**REVIEW OF APPLICATION FOR RE-CERTIFICATION
OF THE COLLINS PROJECT
FOR THE LOW IMPACT HYDROPOWER INSTITUTE**

Prepared by:
Patricia McIlvaine
July 6, 2017

Figure 1 – FERC Project Boundary (provided by Ampersand Collins Hydro LLC)

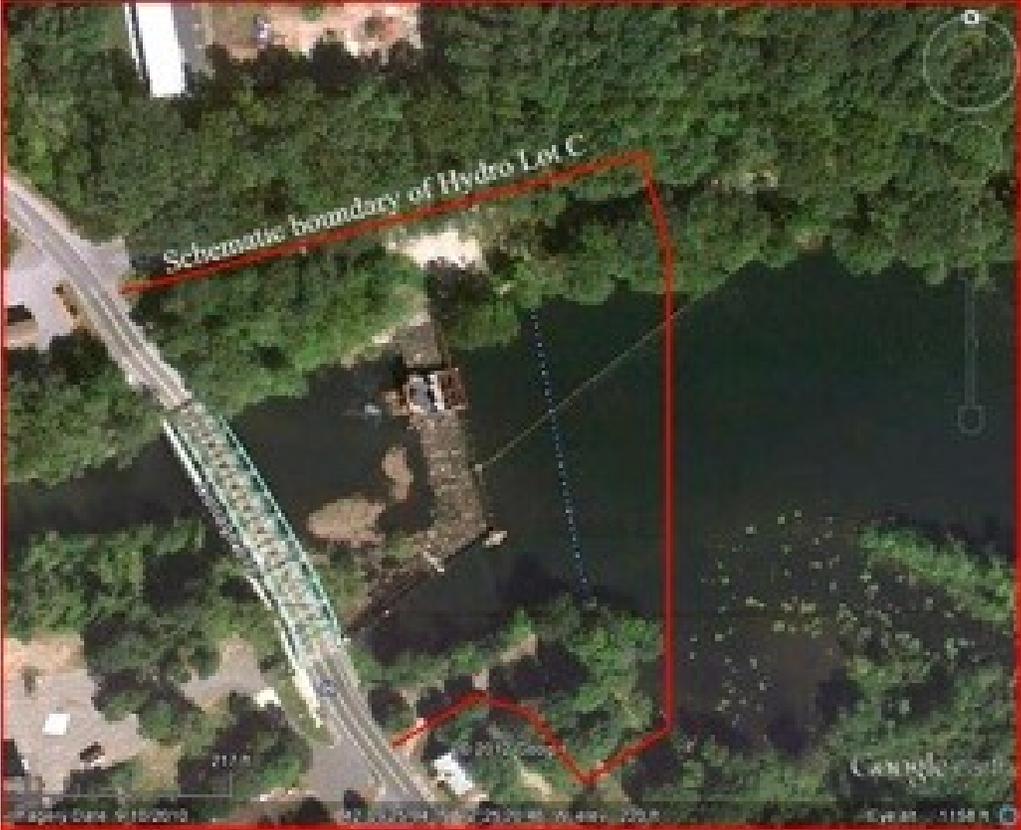
It appears the informal portage is within the FERC Project boundary identified to LIHI. Figure 1 in Appendix A shows the FERC boundary. This passage essentially follows the path indicated on Figure 2 in Appendix A. As required by FERC regulations, an Exemptee must either own all lands, or have “rights” from the owner, necessary for Project operation, maintenance and to fulfill other FERC Exemption requirements. Ampersand reported they lease the project lands from I-MaxMat. Thus, it would appear that the rights would exist to develop this portage trail.

I am recommending that this criterion would be met provided some additional development is made to either the existing informal portage trail or a new one be located on the east side of the river. I believe this is appropriate because 1) the License Exemption required that “access be provided” and 2) the previous Owner made a commitment to do so in the agency required “needs study” and to comply with the original LIHI Condition. To address the concern about significant increase in use of the area, especially adjacent to the Columbia Gas property, I recommend that Ampersand coordinate with the Chicopee 4 Rivers Watershed Council to develop this portage and an approach to minimize significant advertisement of the portage.¹ Not developing any parking facilities or picnic areas would help minimize public use of the area. Coordination with Columbia Gas representatives in this planning could help alleviate their concerns. A condition has been recommended to address this issue.

Condition 2. Within 30 days of issuance of LIHI re-certification, the Owner shall convene a meeting(s) with interested stakeholders to discuss an approach that would result in formalization of a portage route around the Collins Dam, while also addressing measures to help minimize over-use of the area adjacent to the Columbia Gas property by members of the boating public. Minutes of the meeting(s) shall be issued to meeting participants and LIHI. If a formal agreement, including an implementation schedule of not later than the spring of 2018, for the improvement to and maintenance of such a portage cannot be reached by November 30, 2017, LIHI shall be provided a detailed explanation why an agreement is not possible. That LIHI notification shall be provided within 30 days of when that decision is reached. LIHI at that time may find that the certification can nonetheless continue, or must be rescinded due to not meeting the requirements of this Criterion. Should an agreement be reached, the Owner shall notify LIHI within 30 days of when the portage and signage identifying the portage is complete.
